SUBJECT: Contract Number W912P8-09-D-0046 0008, WBV-14c.2 - Westwego to Harvey Canal, Hurricane Storm Damage Risk Reduction System, New Westwego P.S. to Orleans Village, Phase 2, First Lift Levee and Floodwalls at Westminster Pumping Station, Jefferson Parish, LA

AMENDMENT OF SOLICITATION/MODIFICATION OF CONTRACT

CO-001 Government Furnished Sheet Piling

Contract W912P8-09-D-0046 0008, WBV-14c.2 - Westwego to Harvey Canal, Hurricane Storm Damage Risk Reduction System, New Westwego P.S. to Orleans Village, Phase 2, First Lift Levee and Floodwalls at Westminster Pumping Station, Jefferson Parish, LA is hereby modified to remove approximately 2,346 SF of Contractor Furnished PZ-27 Sheet Piling and replace with 2,520 SF of Government Furnished PZ-27 Sheet Piling.

SHEET IDENTIFICATION
C-11

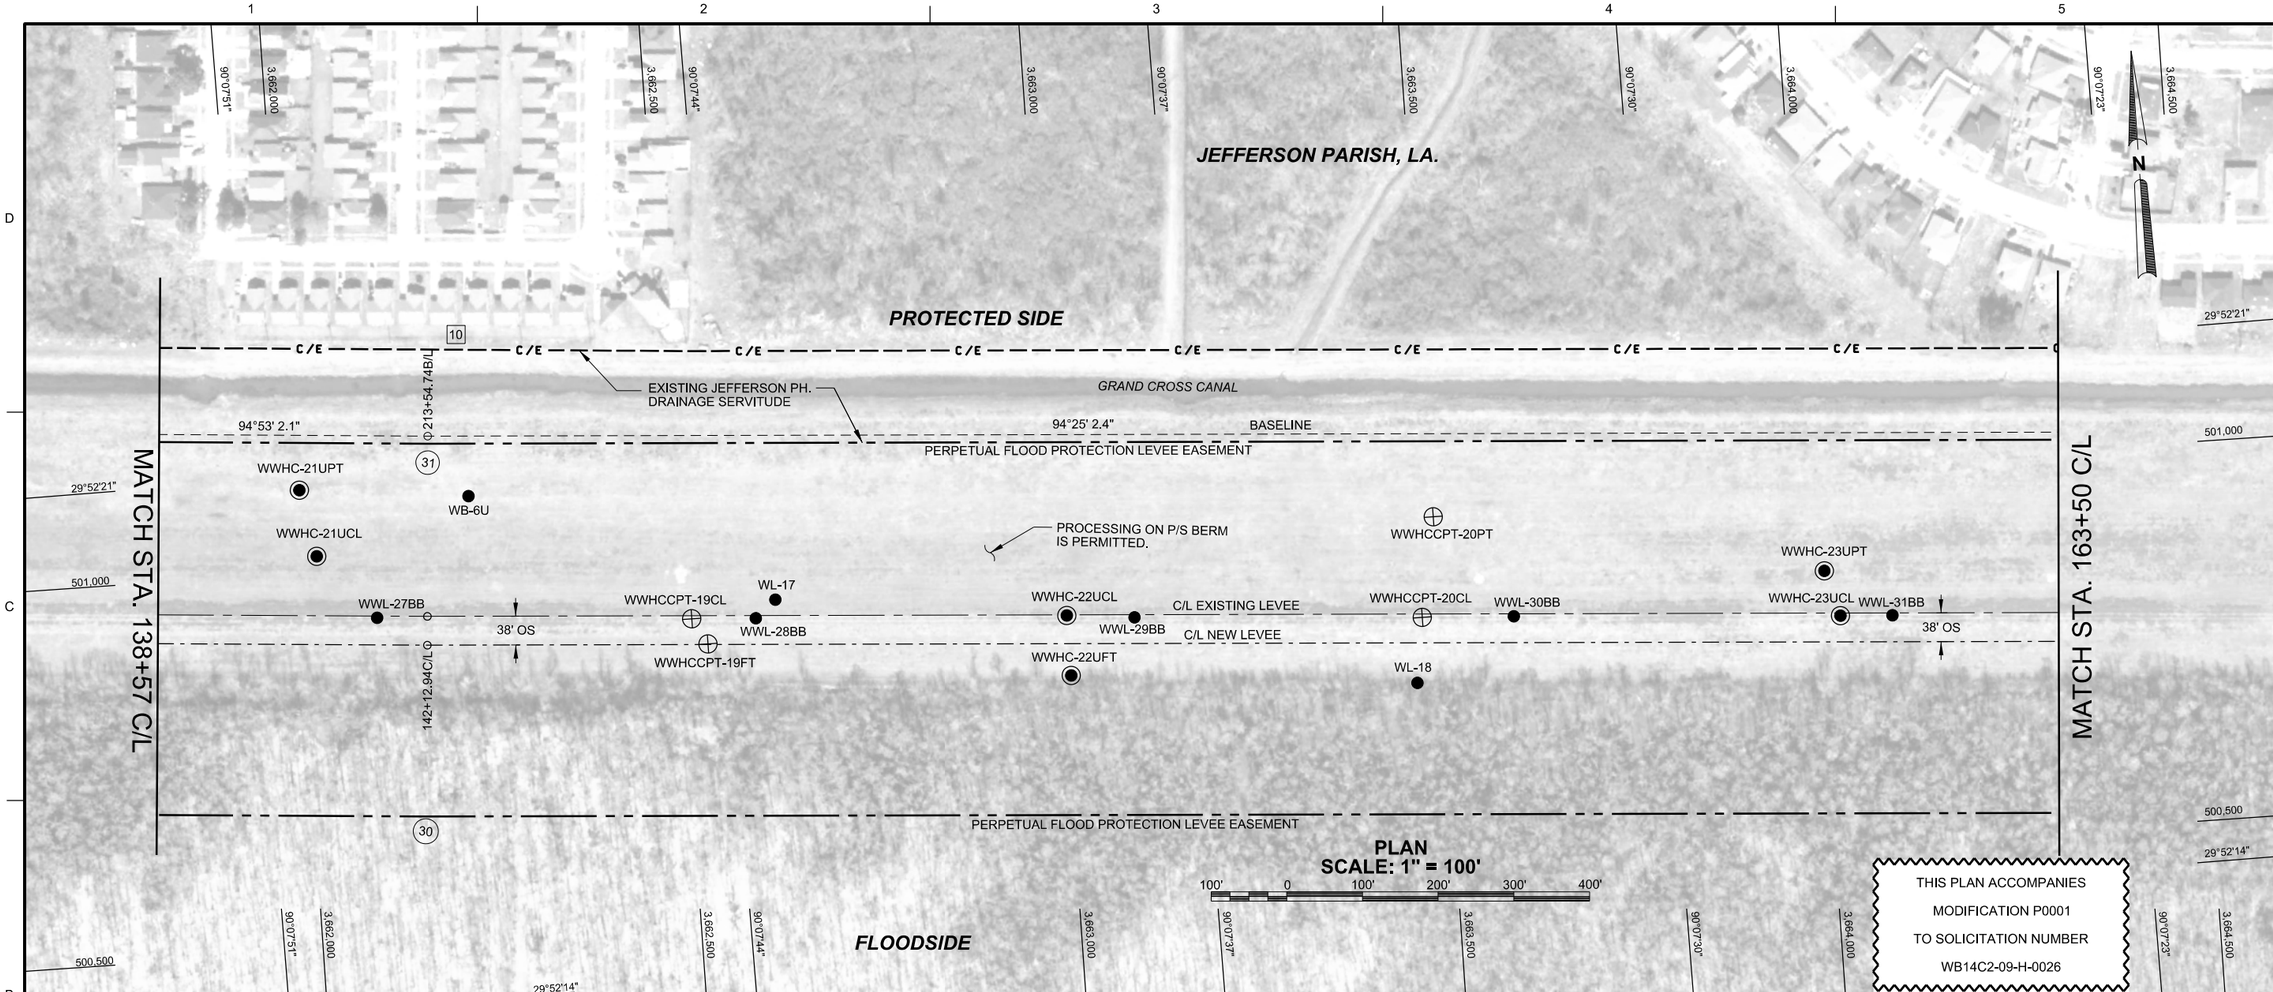
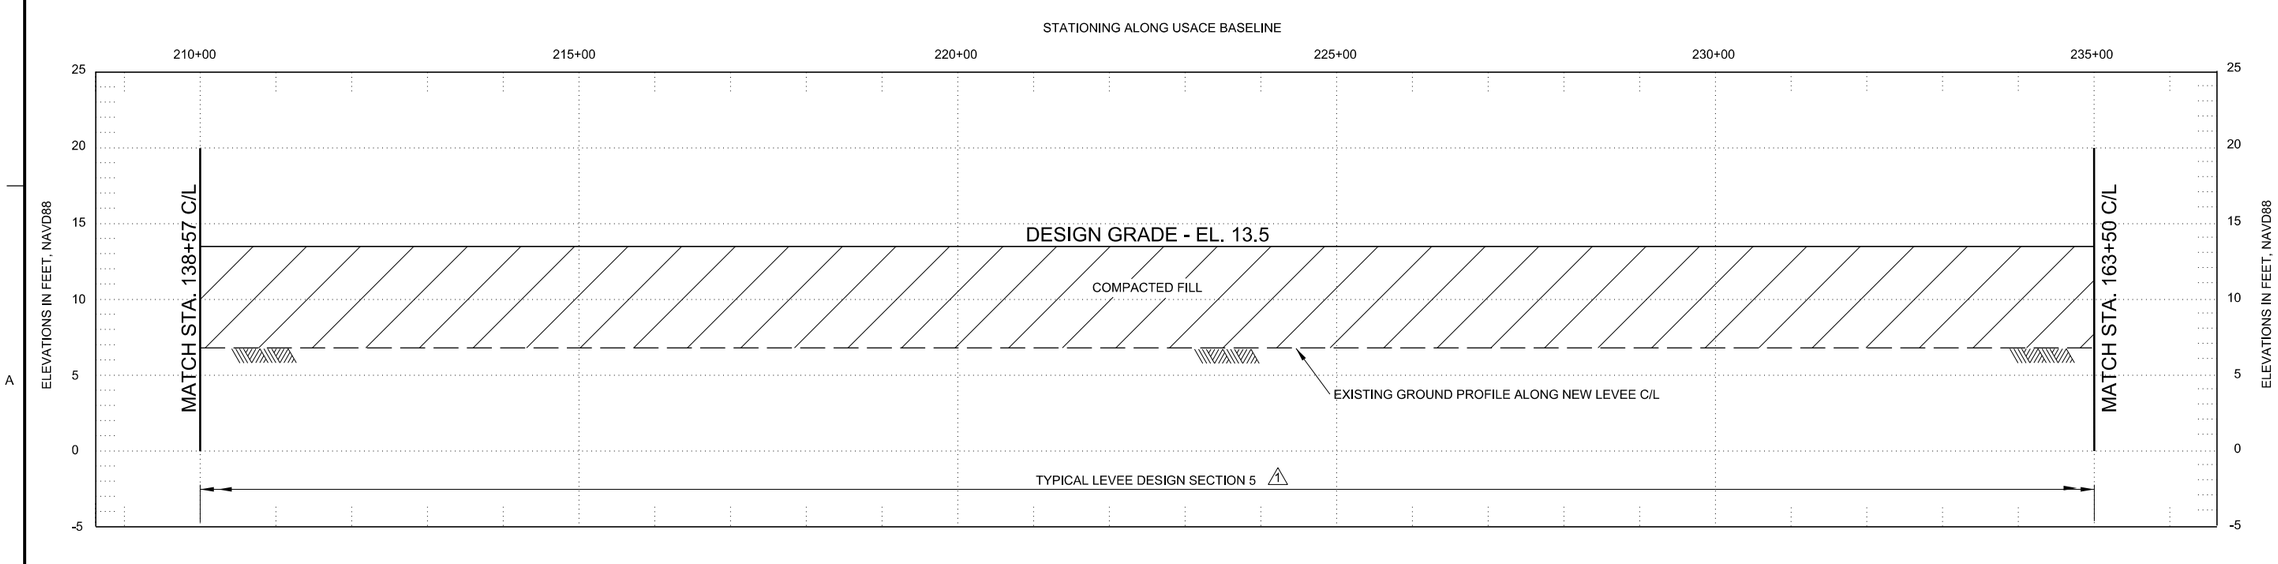
MARK	DESCRIPTION	DATE	APPR.
1	MOD. # P0001 - REVISED TYPICAL SECTION IN PROFILE.	03/15/11	B.J.L.

SHEET IDENTIFICATION
C-12

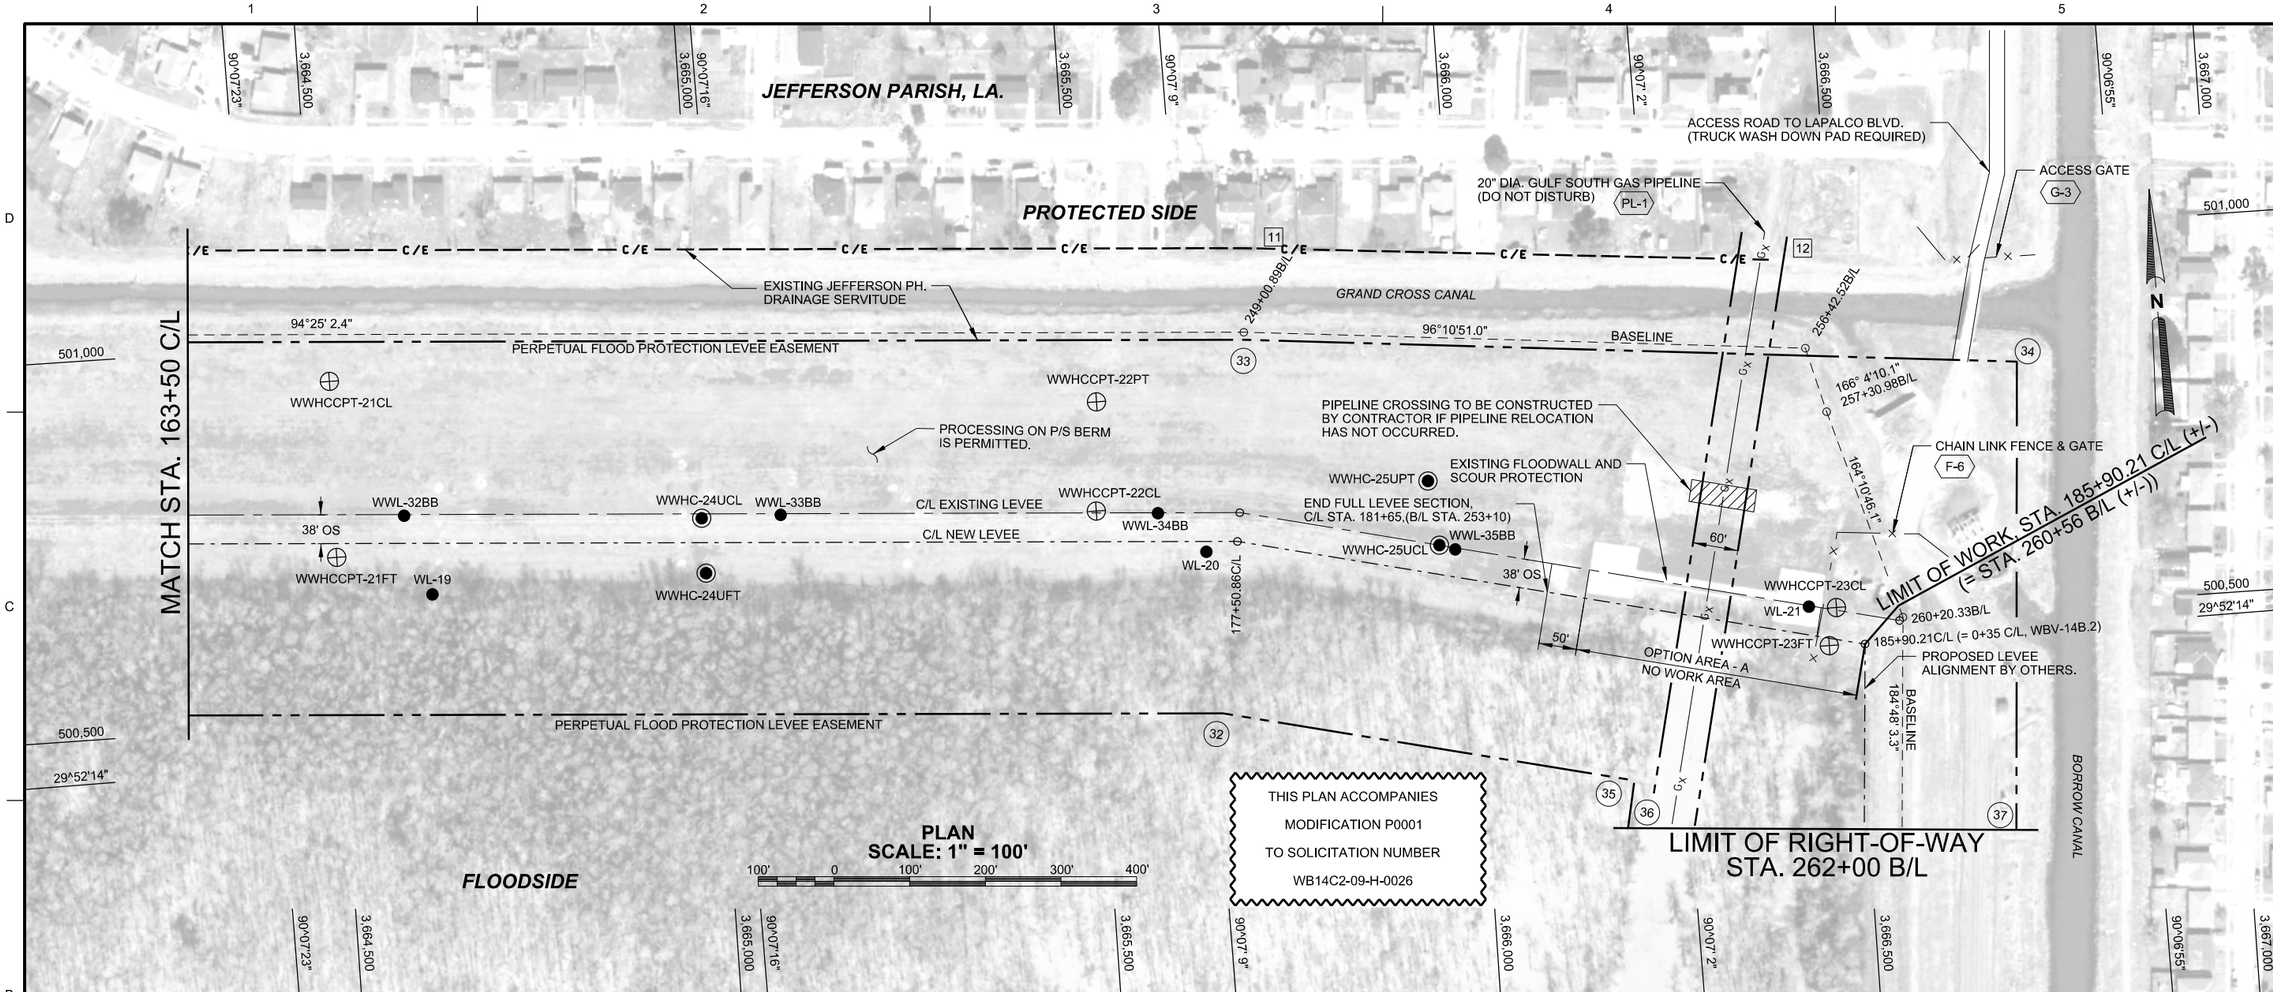
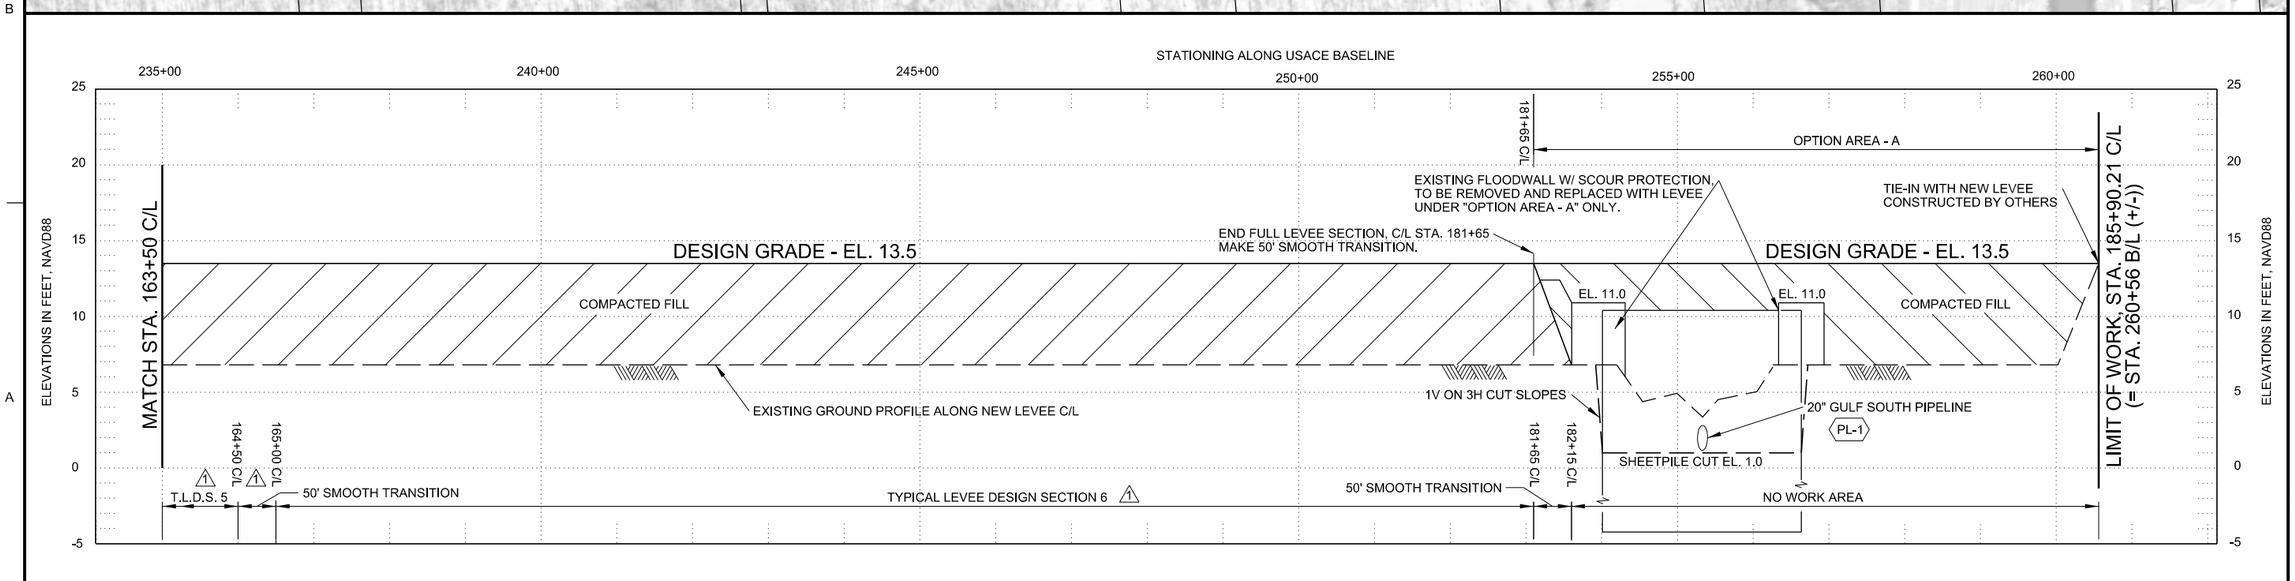
MARK	DESCRIPTION	DATE	APPR.
1	MOD. # P0001 - REVISED TYPICAL SECTIONS & LIMITS IN PROFILE.	03/15/11	B.J.L

TYPICAL LEVEE DESIGN SECTION 1 △1

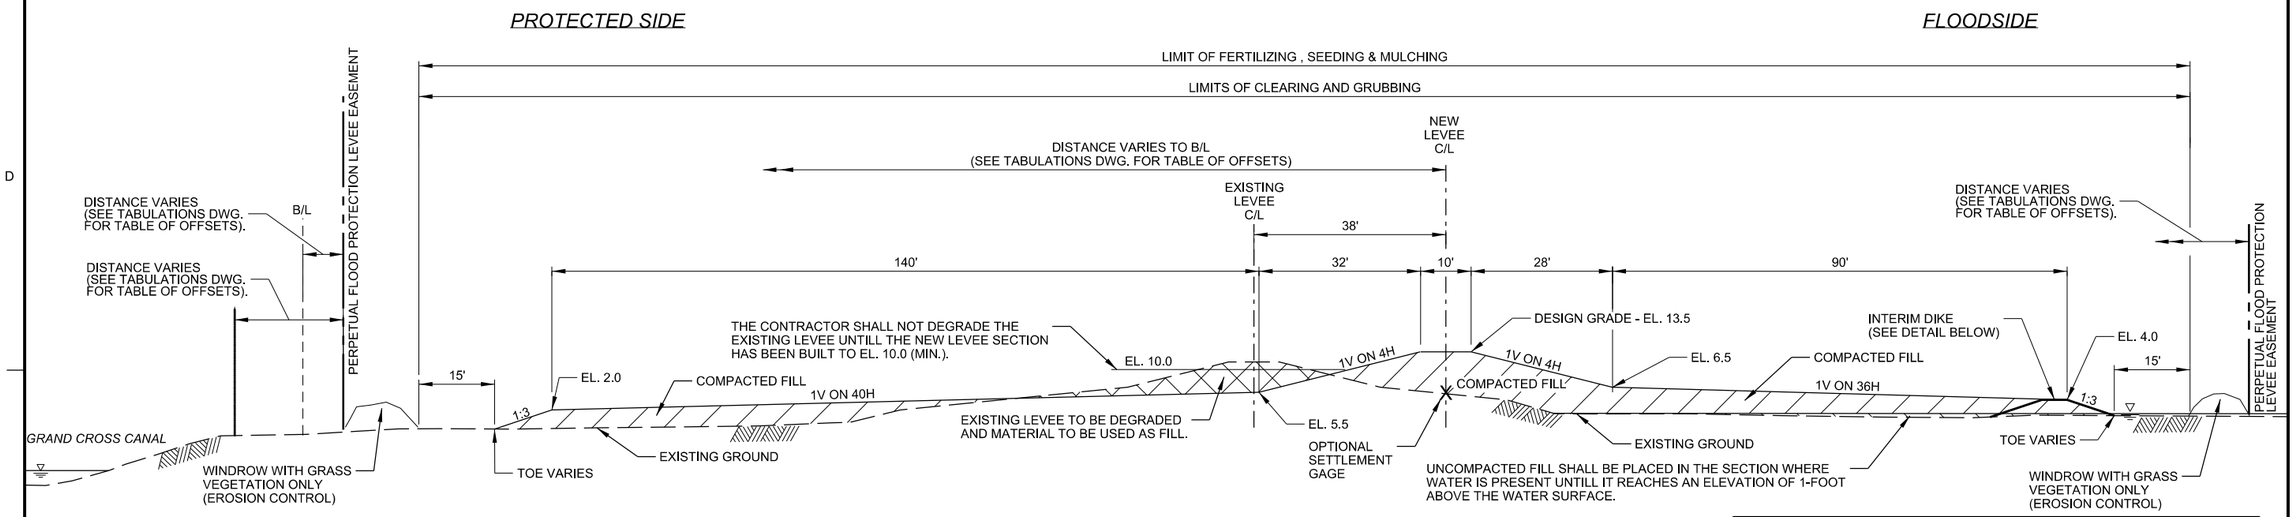
MARK	DESCRIPTION	DATE	APPR.
△1	MOD. # P0001 - REVISED LIMITS ON TYPICAL SECTION 1.	03/15/11	B.J.L.
